**Project** Proposed Barn Conversions at  
Tybroughton Hall, Whitchurch SY13 3BB

**Drawing** Barn A as Proposed

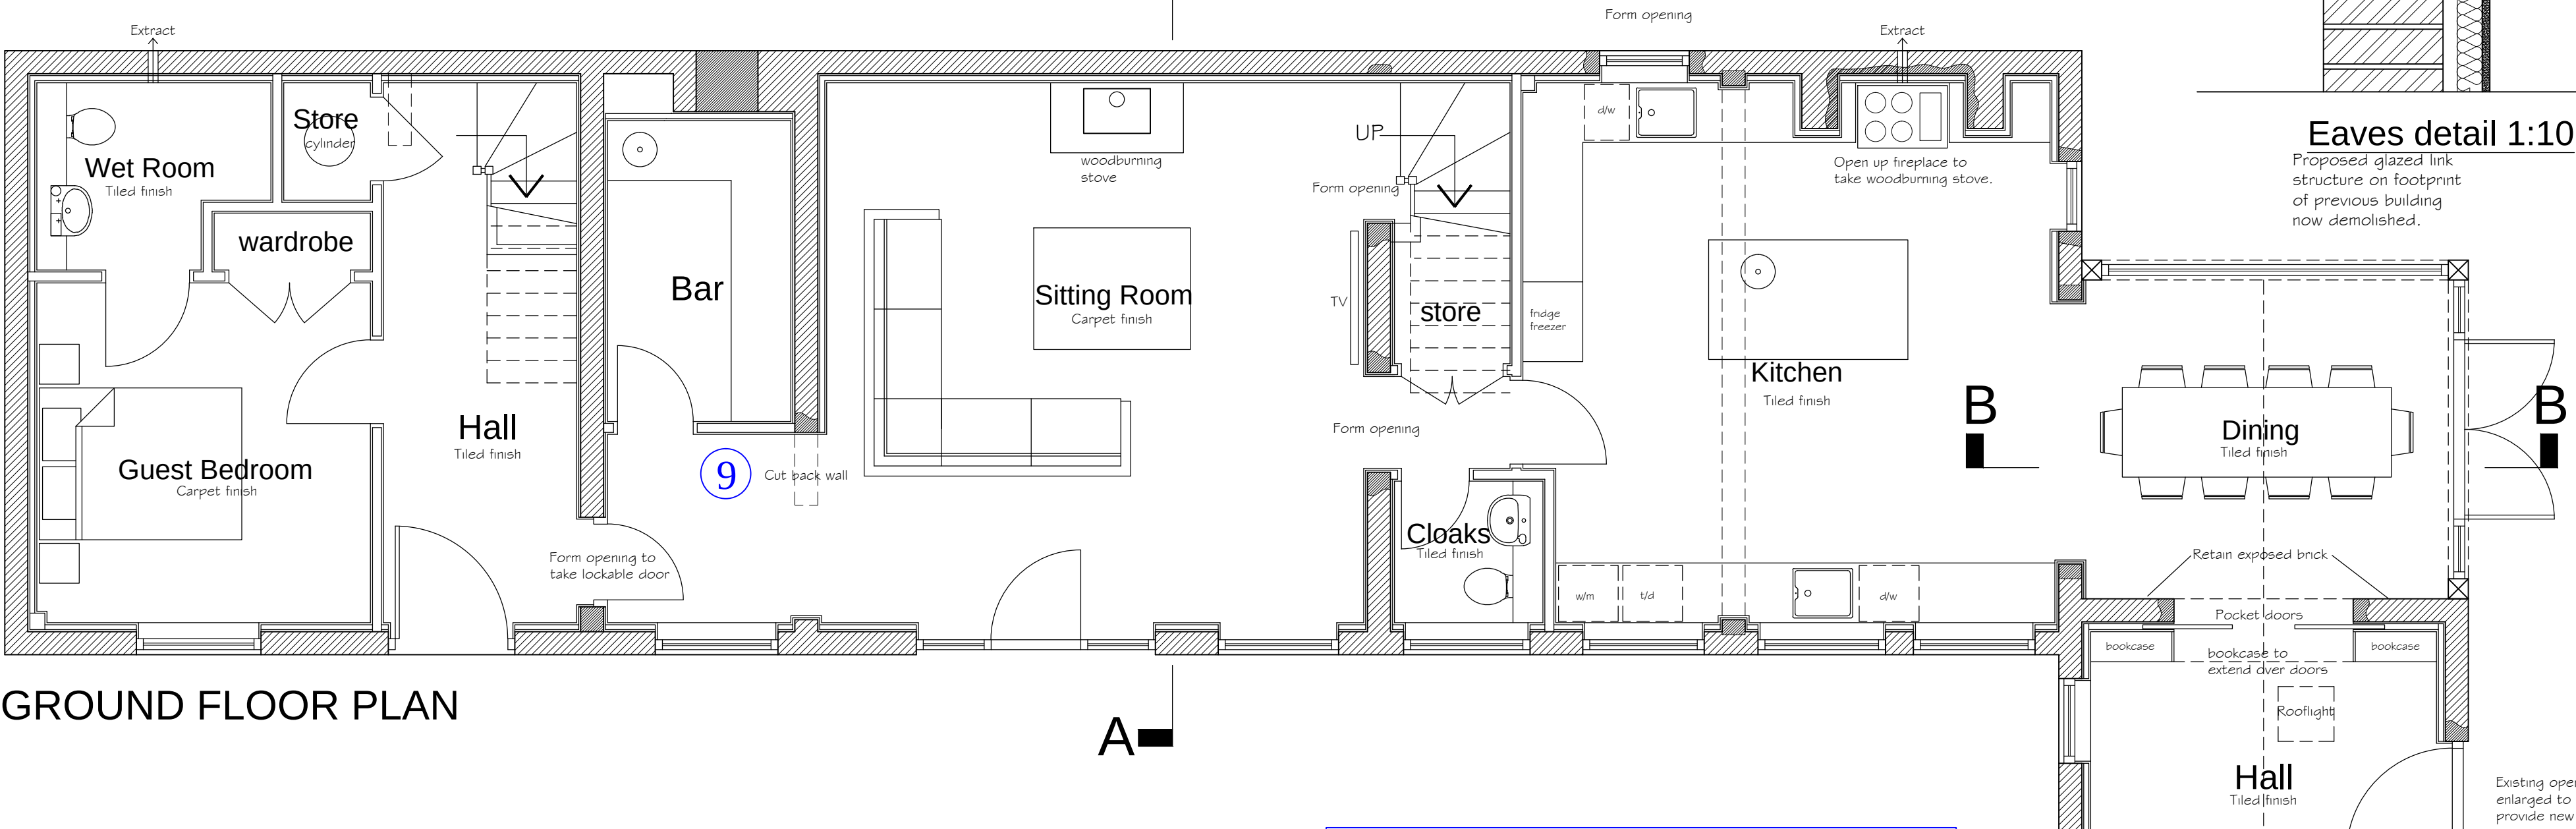
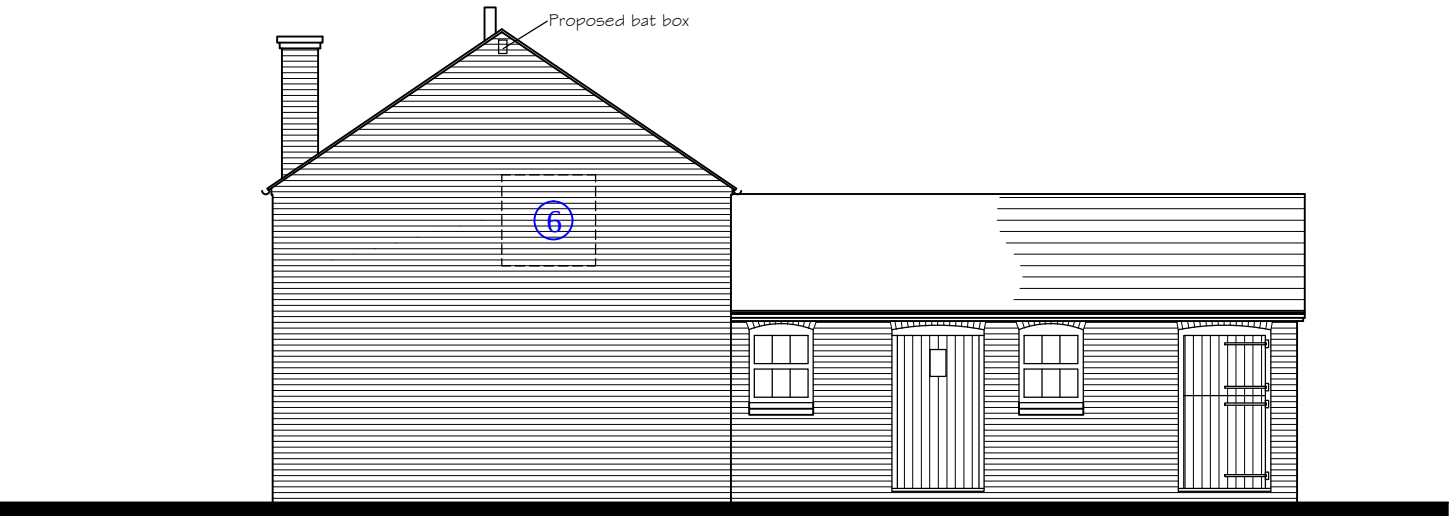
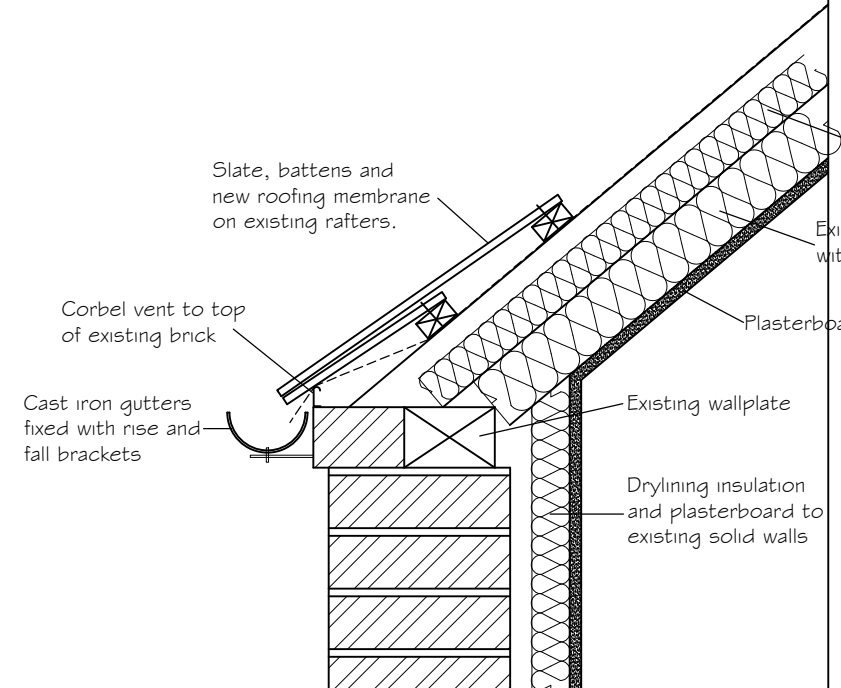
- Proposed Amendments:
- 1 - Treatments of existing openings revised.
  - 2 - Front door and glazed screen swapped.
  - 3 - Additional rooflights added.
  - 4 - Rooflights moved up roof slope.
  - 5 - Flue moved over.
  - 6 - Modern window built up.
  - 7 - Omitted.
  - 8 - Door details revised.
  - 9 - Minor revisions to internal layout including retention of existing wall.
